SAN FRANCISCO PLANNING DEPARTMENT

Executive Summary Amendments to Design-for-Development

Date: October 17, 2019
Case No.: 2007.0946CWP-03
Project Address: **Candlestick Point**
Zoning: Candlestick Point Activity Node Special Use District
Location: *Candlestick Point*
Project Sponsor: Kofi Bonner
FivePoint
1 Sansome, Suite 3200
San Francisco, CA 94104
Staff Contact: Mat Snyder – (415) 575-6891
Mathew.snyder@sfgov.org

REVISIONS OCTOBER 2019

Figure 2.3 Streets and Path Network

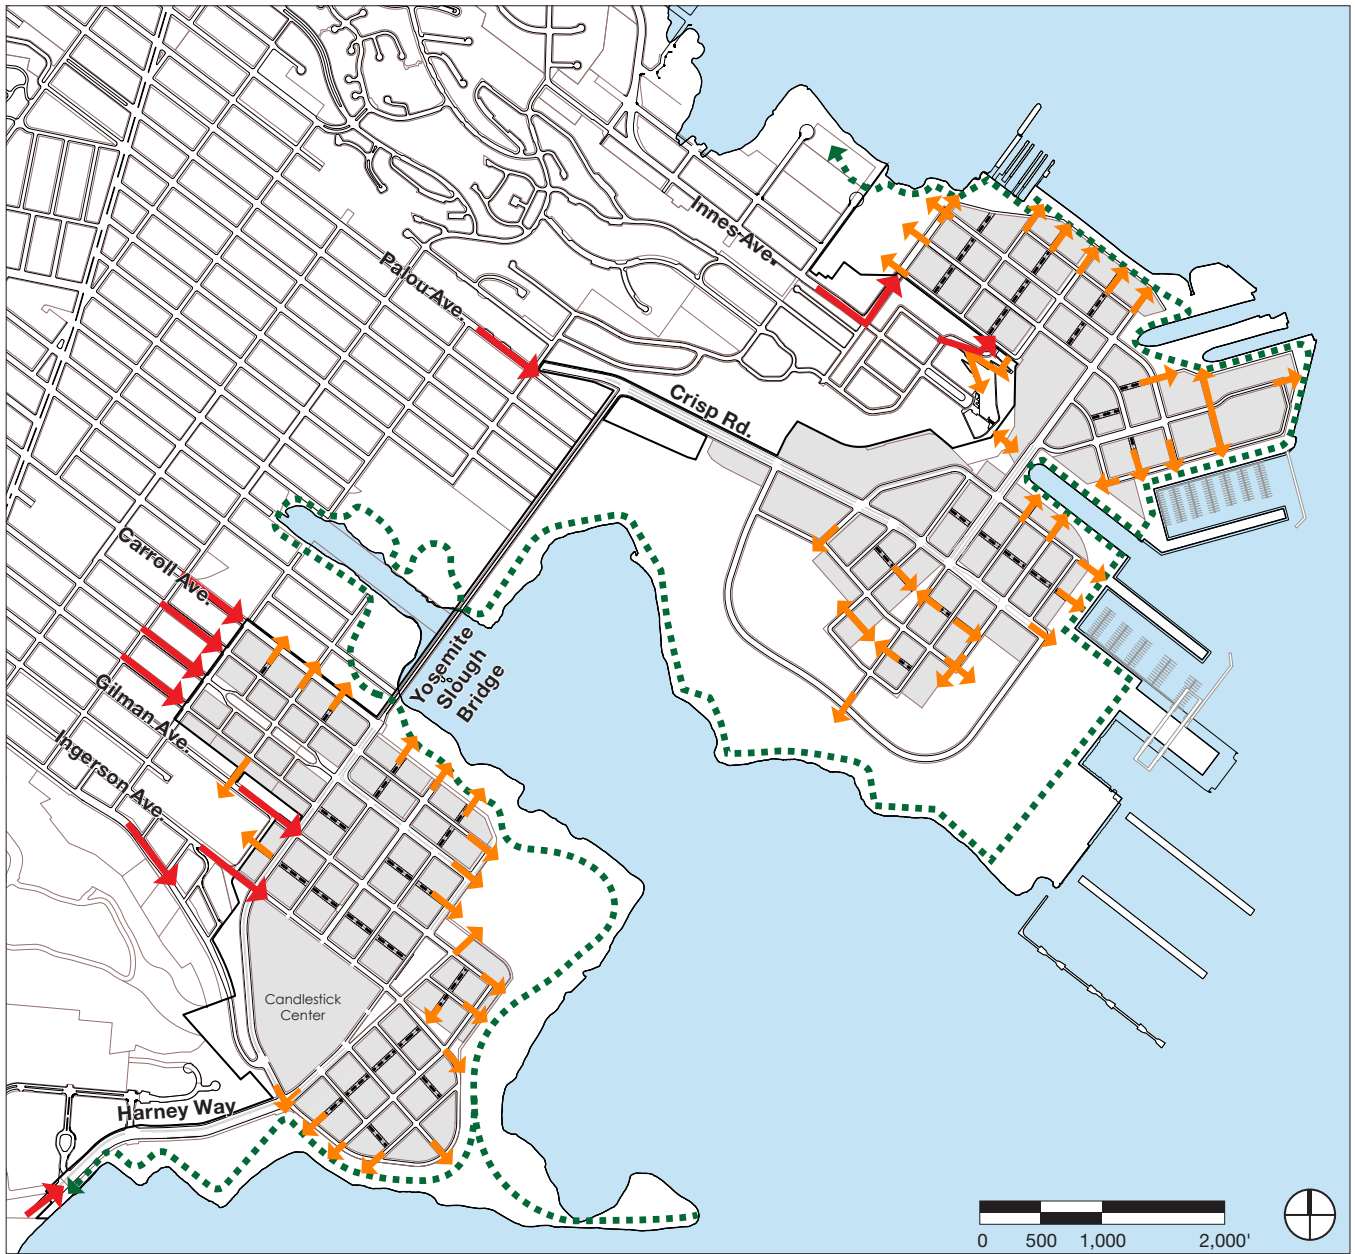
FIGURE 2.3 REVISED – ADDED NOTE AND LABEL “CANDLESTICK CENTER”

Figure 2.4 BRT Route and 5 Minute Walking Radii

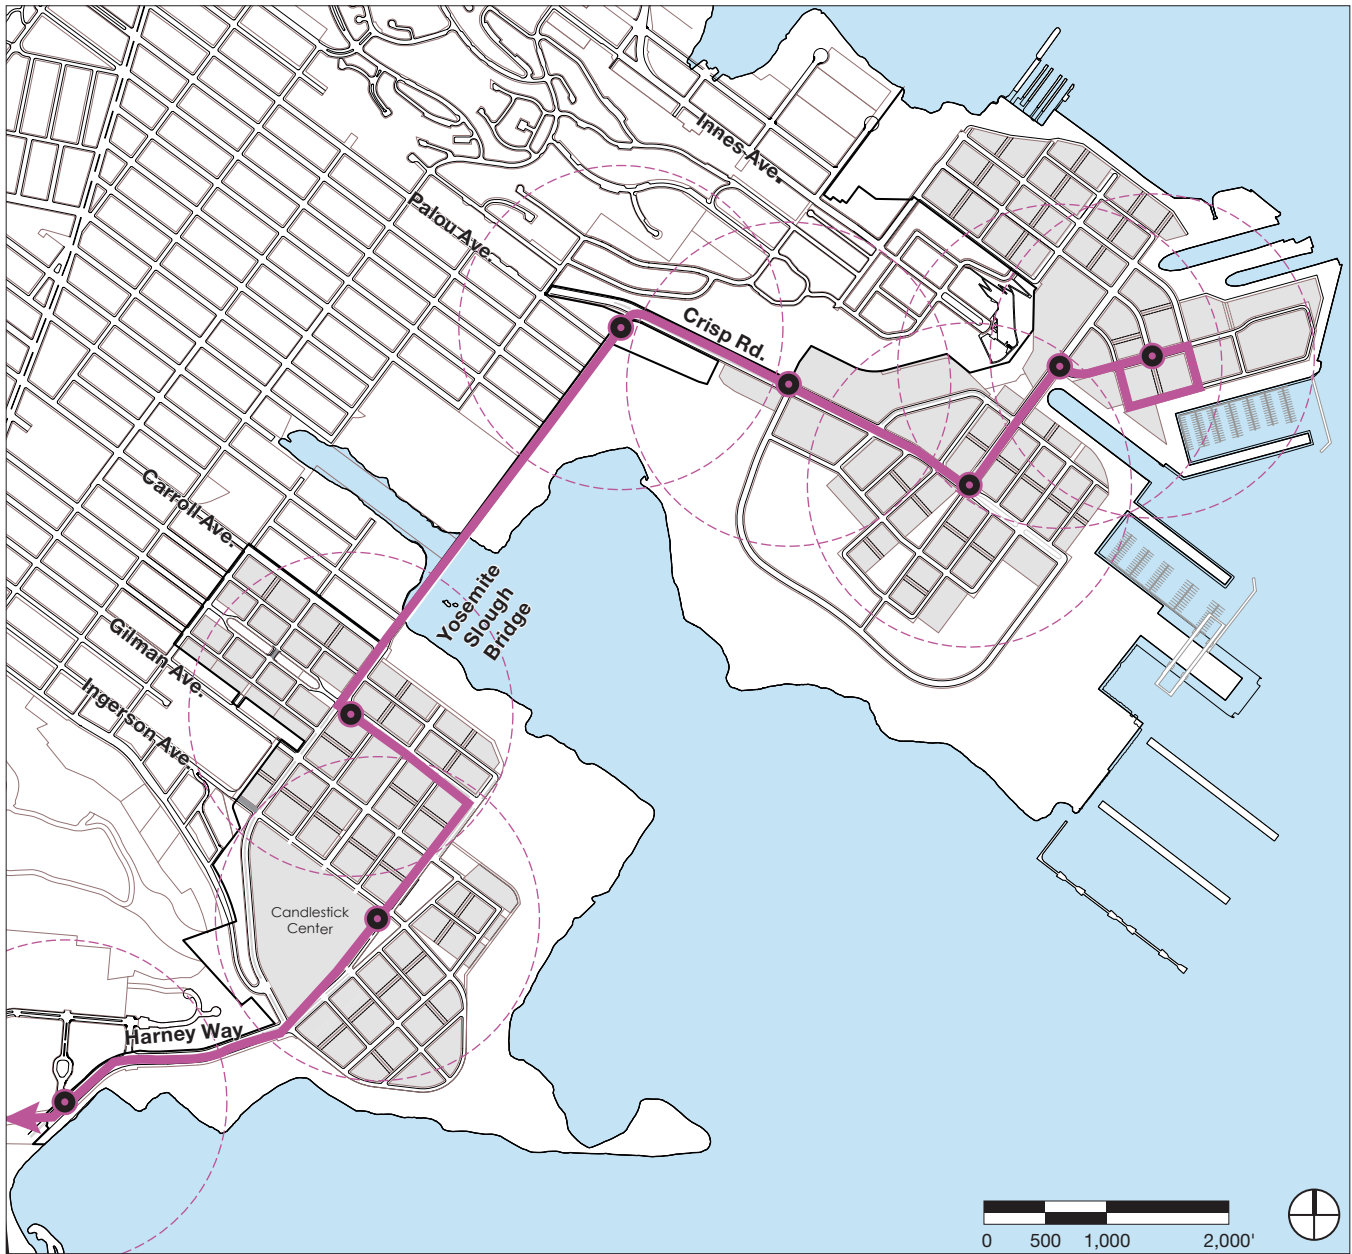
FIGURE 2.4 REVISED – ADDED NOTE AND LABEL “CANDLESTICK CENTER”

Figure 2.5 Bicycle Network

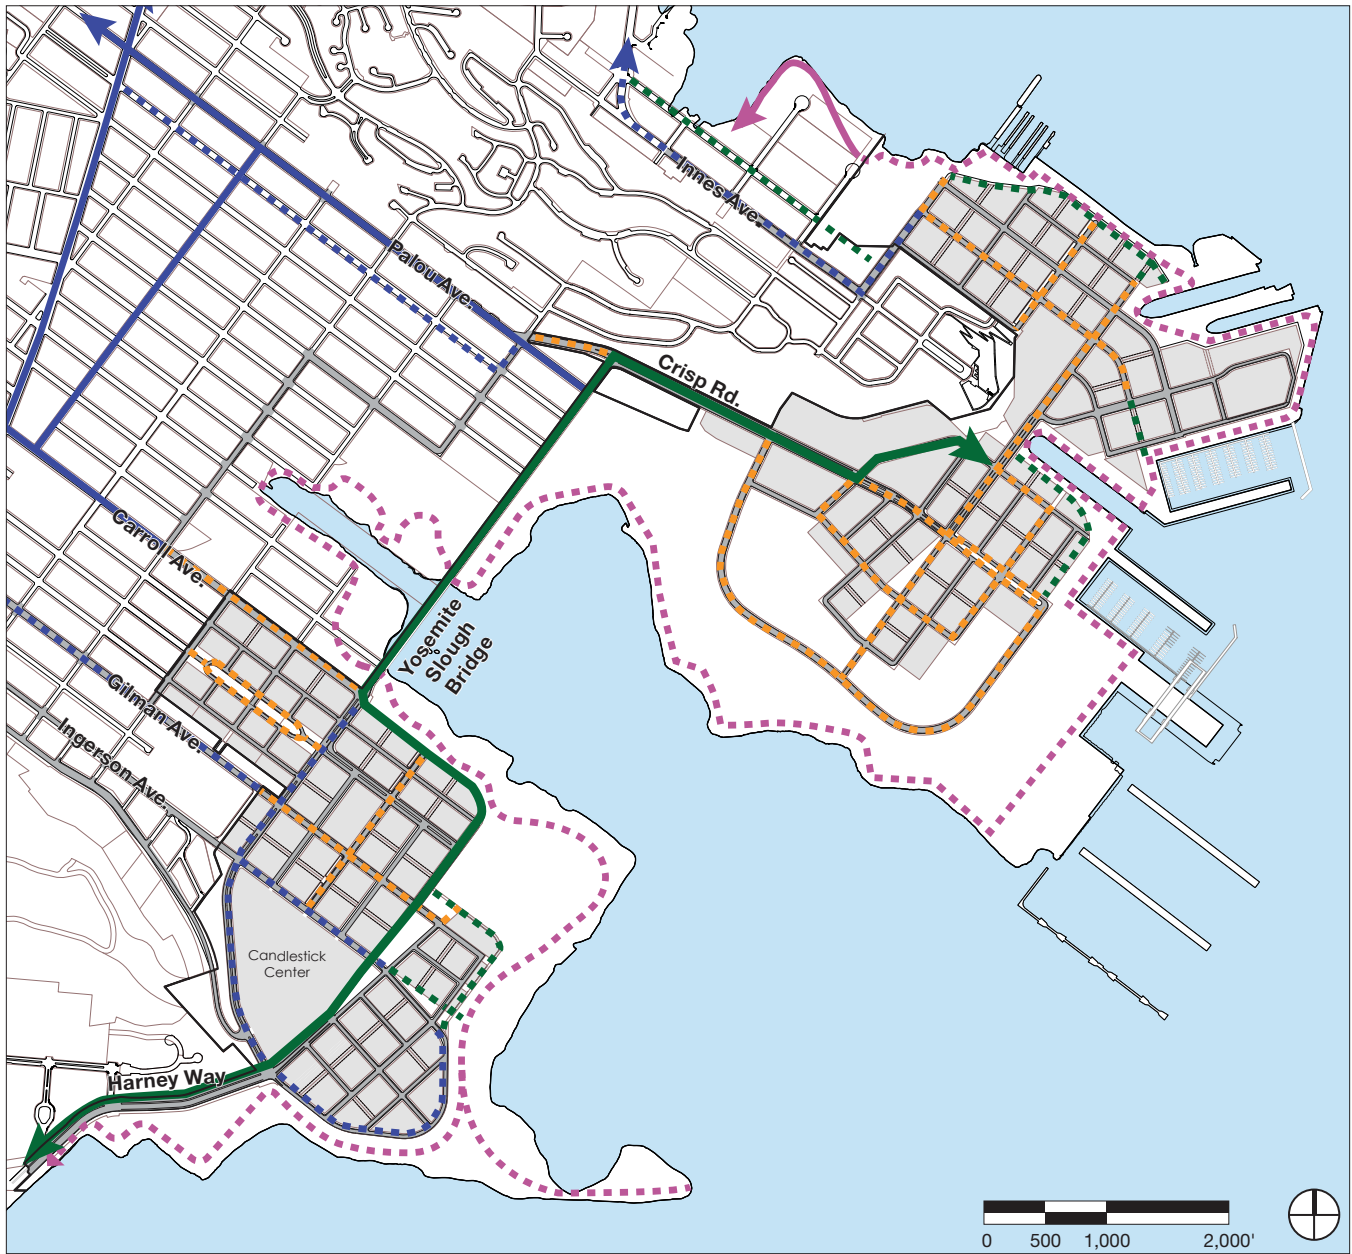
FIGURE 2.5 REVISED – ADDED NOTE AND LABEL “CANDLESTICK CENTER”

Figure 2.6 Urban Placemaking

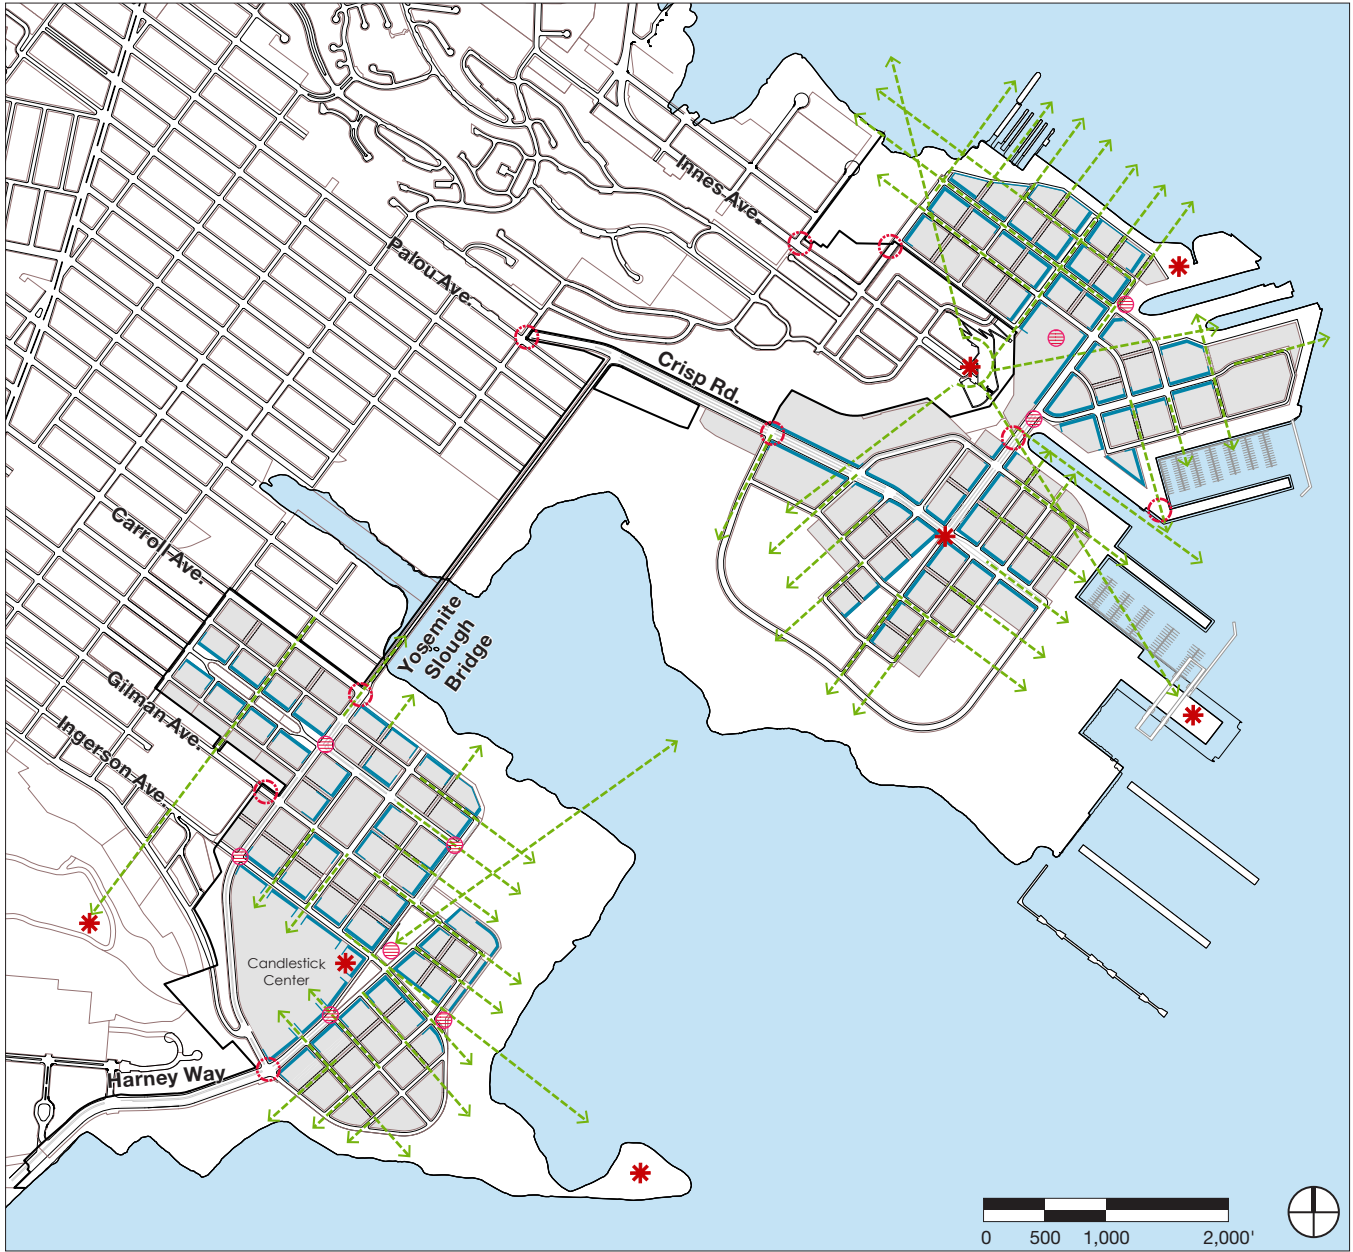
FIGURE 2.6 REVISED - ADDED NOTE, LABEL "CANDLESTICK CENTER", AND ARROWS LEADING INTO CANDLESTICK CENTER

Figure 2.7 Character Neighborhoods

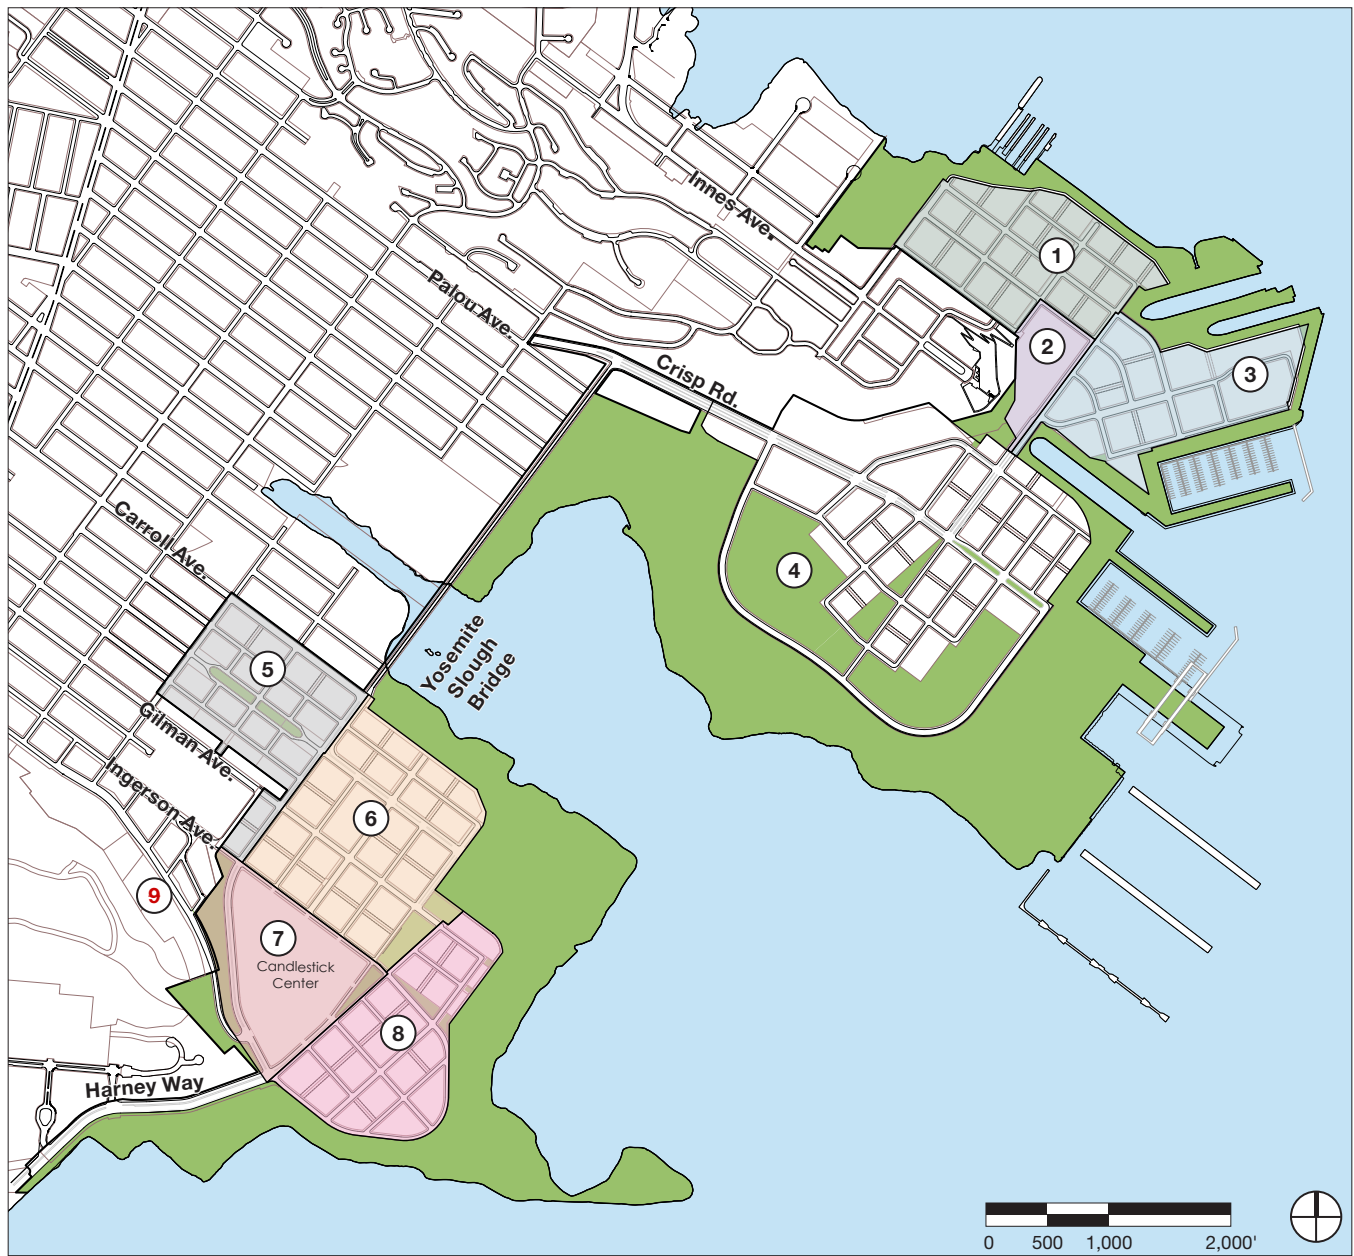
FIGURE 2.7 IS REVISED TO REMOVE JAMESTOWN AND HIGHLIGHT FOR SHIPYARD SOUTH

Figure 3.1 Urban Placemaking

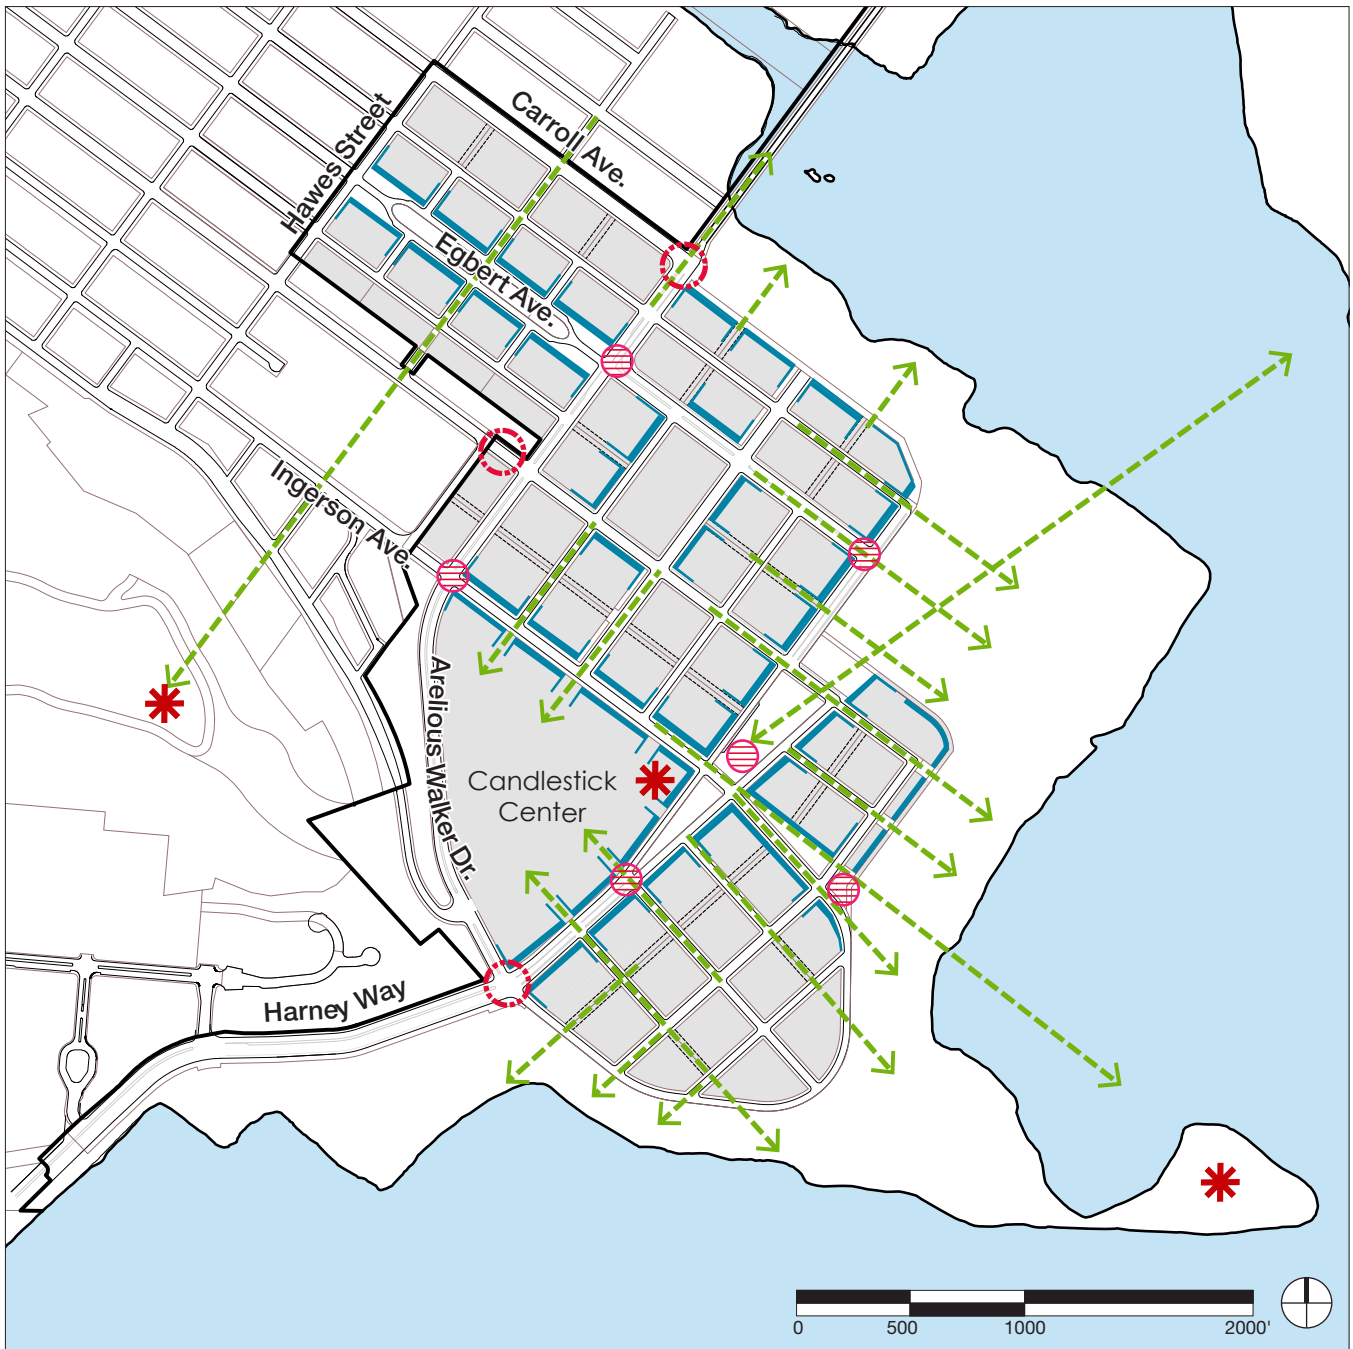
FIGURE 3.1 REVISED - ADDED NOTE, LABEL "CANDLESTICK CENTER" AND ARROWS LEADING INTO CANDLESTICK CENTER
